Meeting Minutes – “Feasibility Meeting”

Project Name: Issaquah Gateway
2290 Newport Way (Former Mull Property)
Meeting Location: City of Issaquah, City Hall

VIA Project # 76314
August 18, 2014

Current Proposal 2014
Illustrative Site Plan

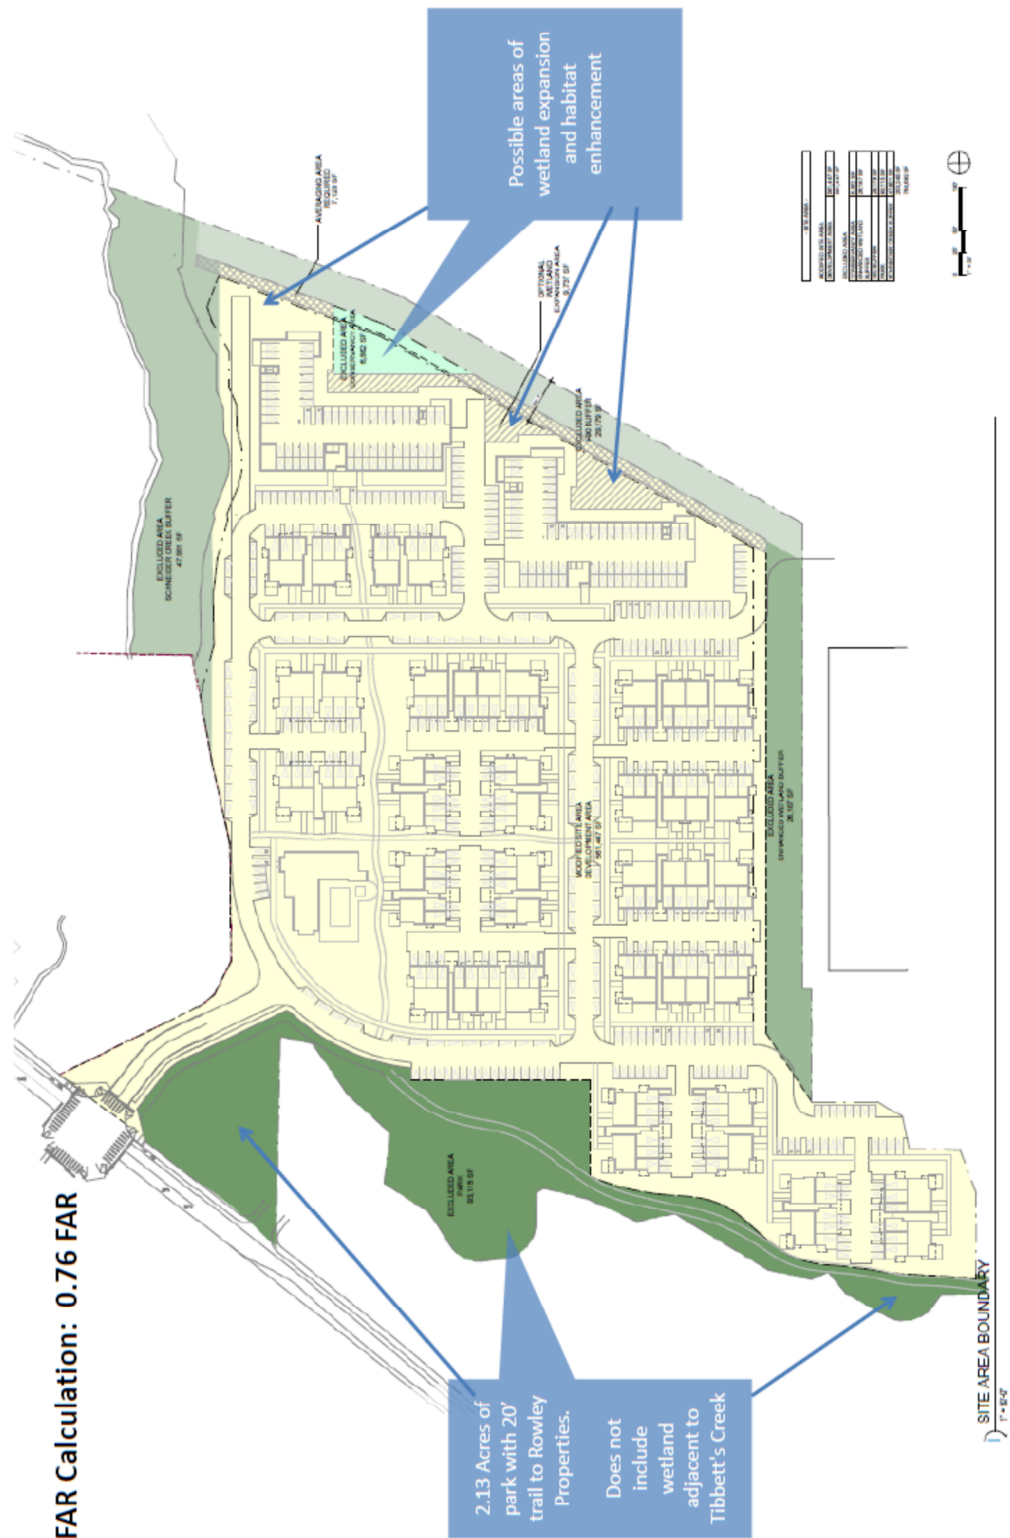
LS commented that she appreciated :

- The positioning of the taller building near I-90 to act as sound buffers and help serve as gateway elements.
- The mid-block pedestrian crossings
- Configuration, landscaping and concealment of the parking courts between walk-up buildings.
